Fort Street Public School – 1005 Upper Fort St, Millers Point NSW - SSD 10340

Thank you for your correspondence of 2 April 2020 inviting comments on an Environmental Impact Statement (EIS) for the State Significant Development (SSD) 10340 for the Fort St Public School Redevelopment, following the submission of the Secretary's Environmental Assessment Requirements (SEARS) on 28 June 2019.

ATTACHMENT A: Detailed Response

Figure 2 Proposed landscape site plan

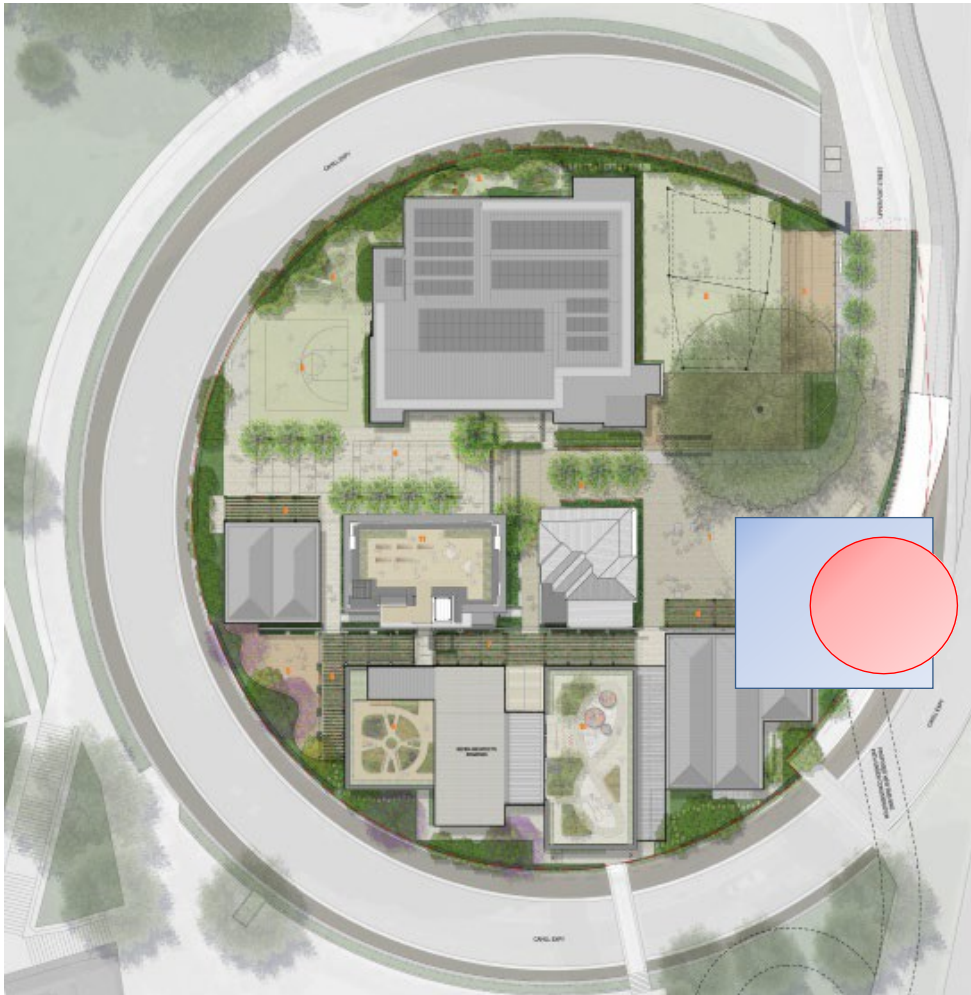
The reconfiguration of site circulation including widening of the existing entrance road and modifications to existing pick-up and drop-off arrangements parking, bike access and waste collection with a turning circle (Figure 2 in red) within the eastern courtyard (Figure 2 in blue).

This courtyard is a multipurpose school playground used by the students and the introduction of a turning circle within the playground for garbage truck collection results in commingle of conflicting uses and significant safety concerns. The playground provides active and passive recreation and is the principal entry space at the school.

As discussed above, the introduction of a turning circle and road occupies over half of the playground. Allowing vehicles in a play environment and the proposed traffic layout is not supported because it results in a poor landscape and school play design.
